SPECIFICATION, SPECIAL PROVISIONS AND DRAWINGS  
REVISION TO STANDARD SPECIFICATIONS AND DRAWINGS

PROPOSAL TO STANDARDS COMMITTEE

PROBLEM(S) ENCOUNTERED: Bridge Standards 707 thru 731 need to be revised and updated for content and presentation.

FIRST DRAFT MINUTES ITEM 03

EXISTING 707-BPBB-01 BRIDGE PRESTRESSED BOX BEAM ADJACENT BOX BEAM (PROPOSE TO DELETE)

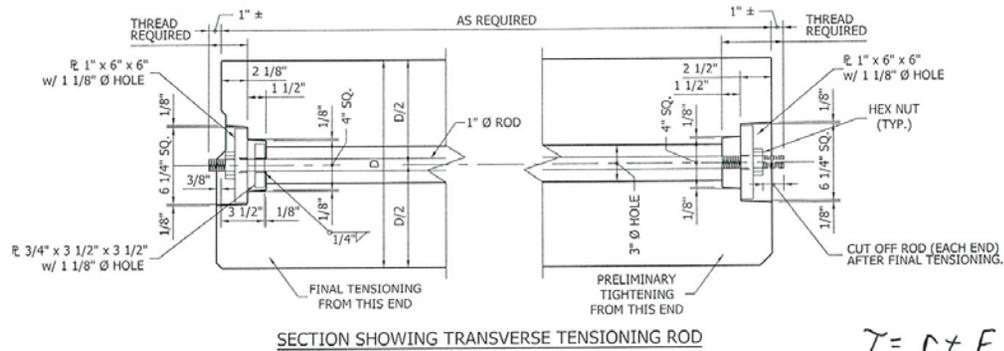
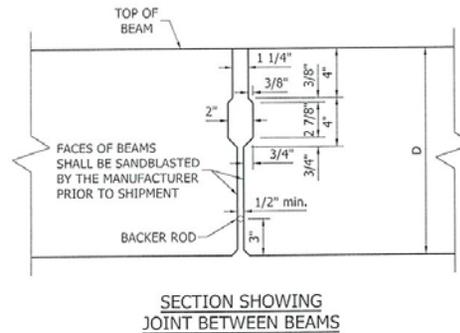
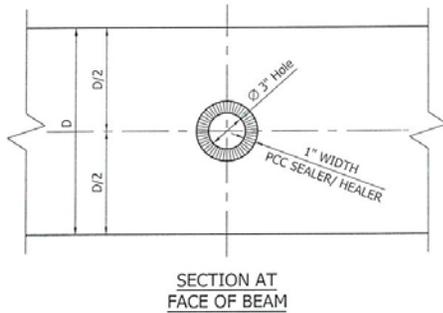
707-BPBB-01.....Propose to delete  
707-BPBF-01 thru 03.....Propose to revise  
707-BPDP-01 & 02, 04 & 05.....Propose to delete  
711-BREB-01 .....Propose to delete  
711-BSTS-01 & 02 .....Propose to delete  
724-BJTS-02.....Propose to delete  
724 BJTS-03 .....Propose to revise  
724 BJTS-04, 05, 06 .....Propose to delete  
731 BRRW-01 & 02 .....New Designation: 731-MSEW-01, 02, & 03

APPLICABLE DESIGN MANUAL SECTION: 406-12A Figure showing transverse tensioning rods will be deleted.

EXISTING 707-BPBF-02 FABRICATION TOLERANCES PRESTRESSED I BEAM (WITH MARKUPS)

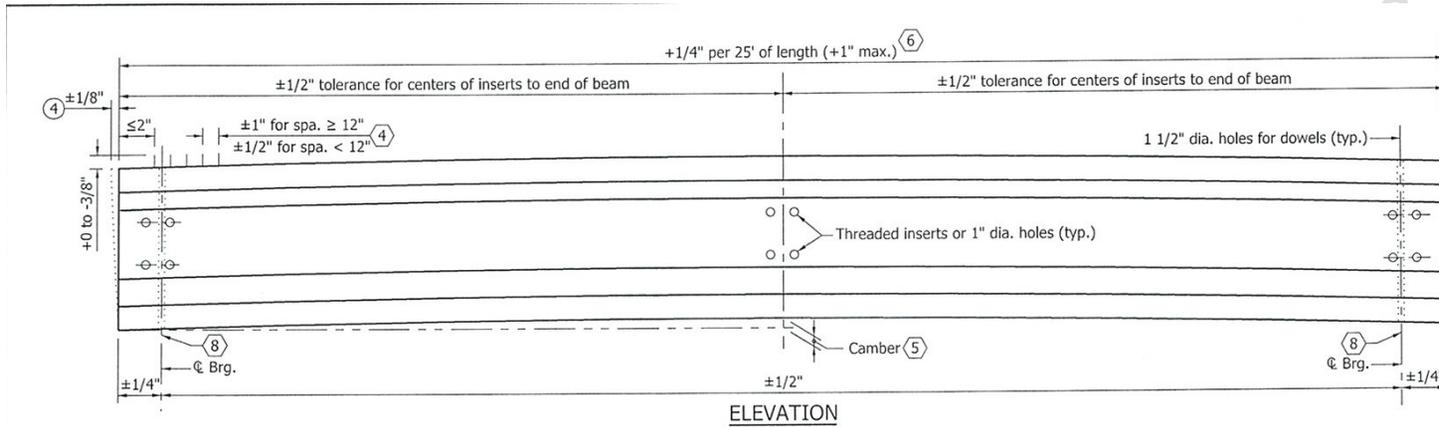
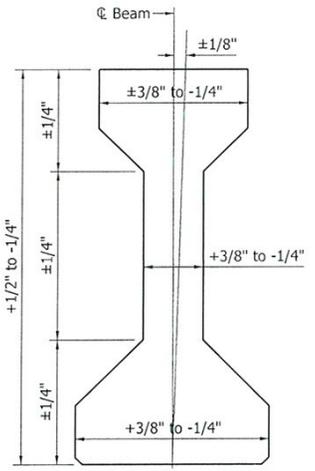
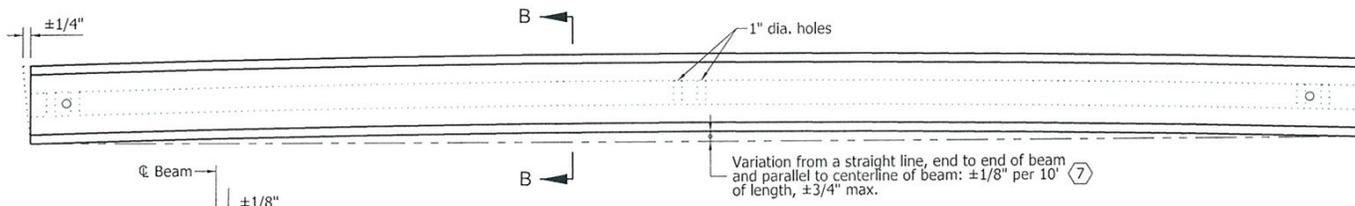
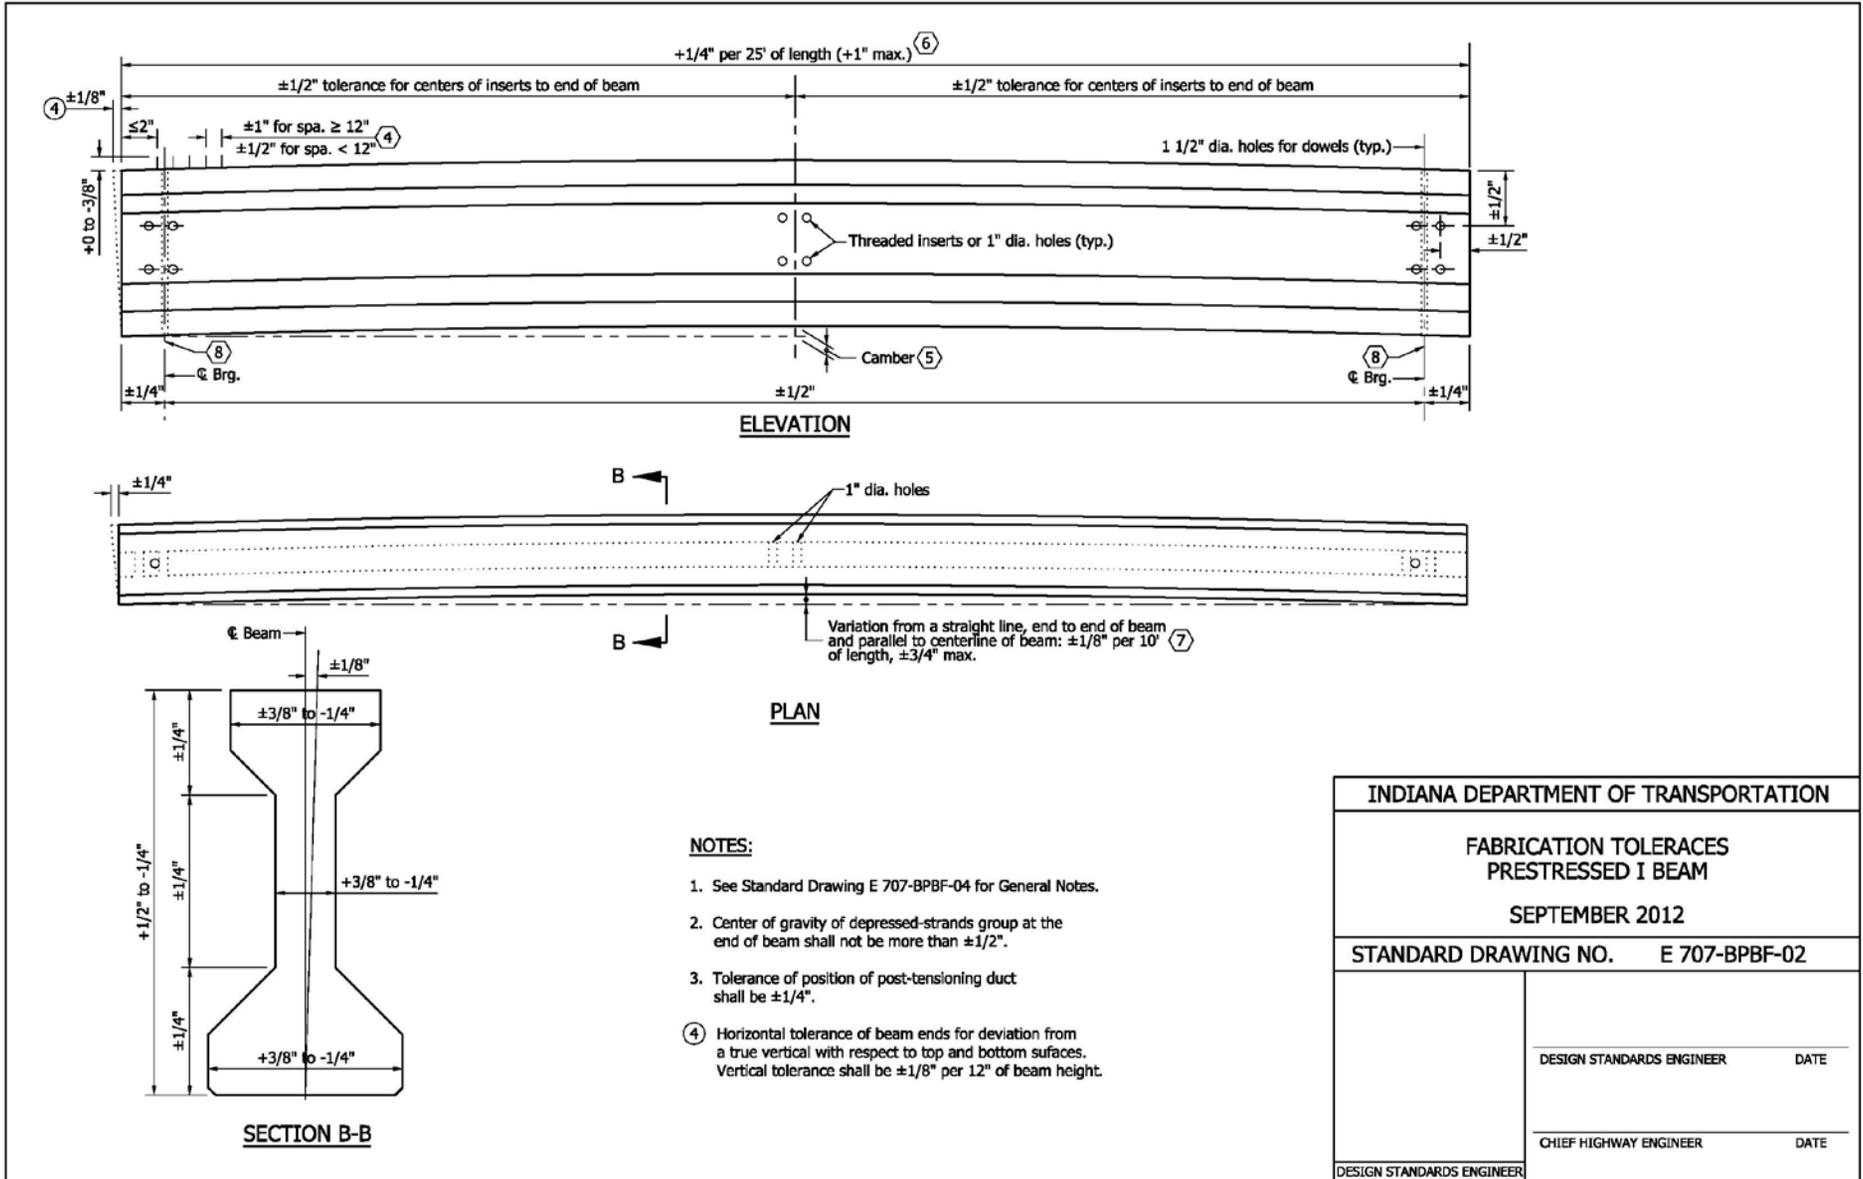
*Tolerance added for holes*

EXISTING 724-BJTS-02 TYPE BS EXPANSION JOINT (PROPOSE TO DELETE)

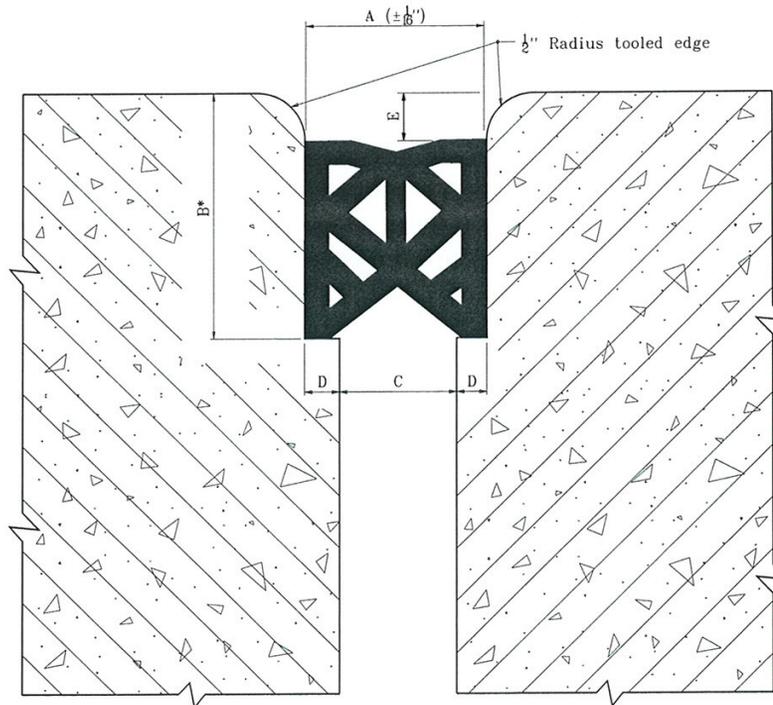
*Standard was to be deleted - has not been approved for use for several years.*

EXISTING 724-BJTS-06 OPTIONAL RAILING VERTICAL REINFORCEMENT SPLICE (PROPOSE TO DELETE)

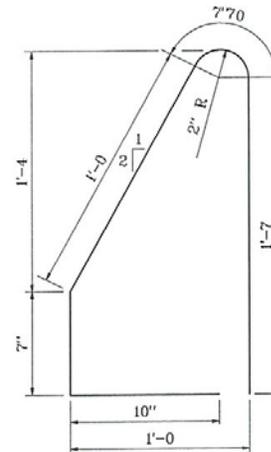
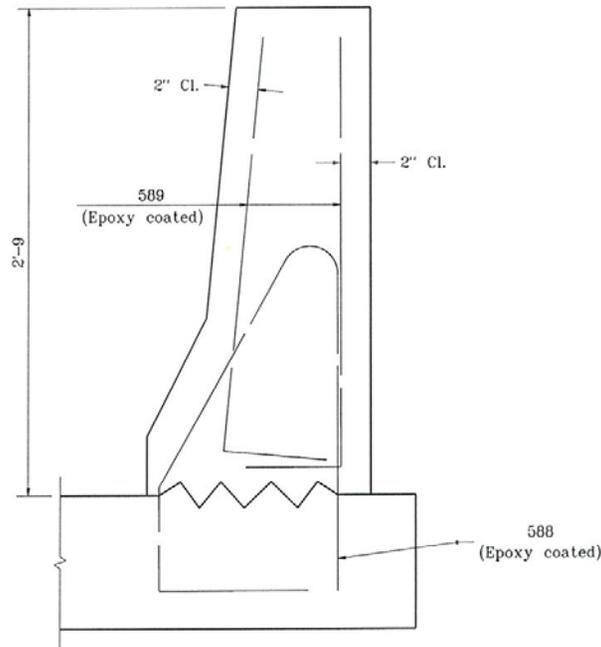
*This alternate can not be allowed. This reinforcement configuration has not been crash tested.*

EXISTING 731-BRRW-01 MSE WALL PRECAST CONCRETE COPING DETAILS (WITH MARKUPS)

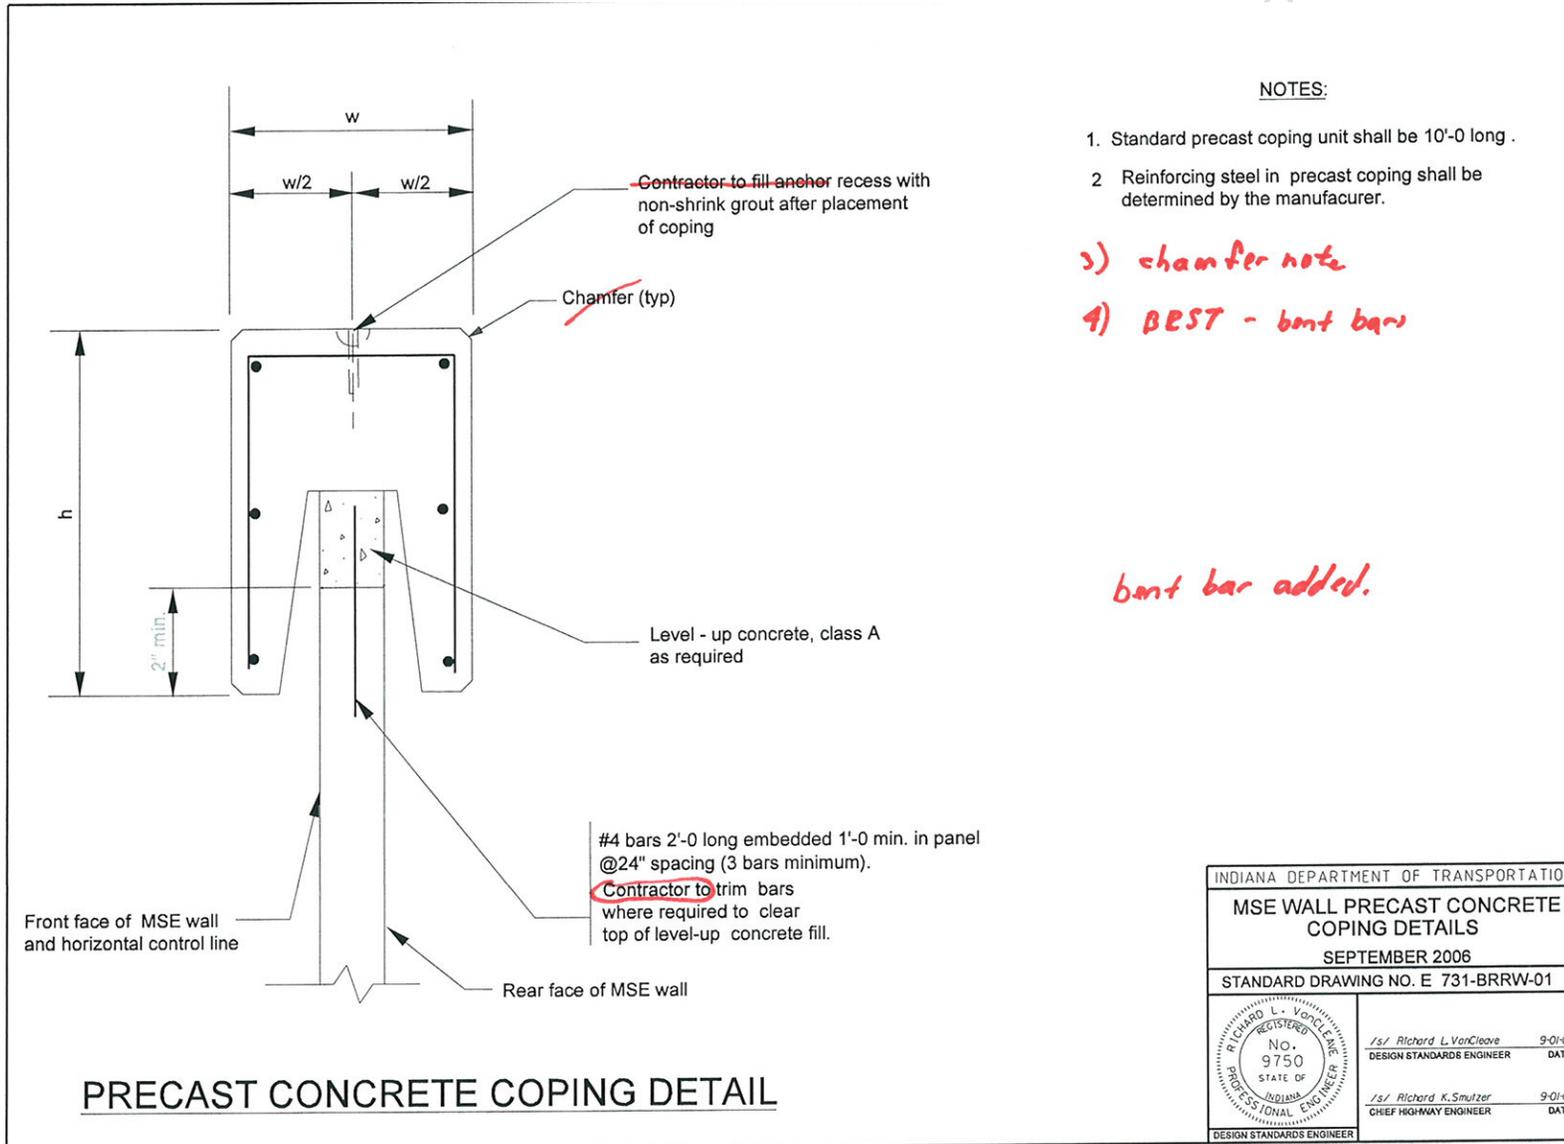
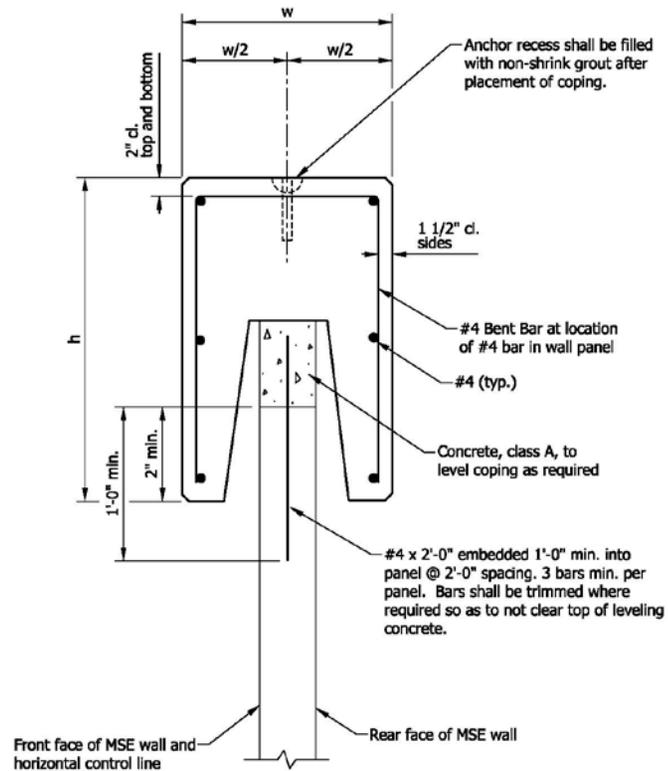
Mr. Miller asked about the MSE wall coping, and if it is resting on the wall by gravity, or if reinforcing bars are sticking up and grouted into the coping (agenda page 26). Mr. Reilman stated that it appears to be not tied down and just sits on there, held down by gravity. Mr. Strain suggested that be looked at by the wall committee, to prevent the meandering appearance of the coping. Mr. Pankow suggested a tighter fit might help. Further discussion revealed that the copings fit too loosely and should be a tighter fit to prevent the pieces from moving around so much.
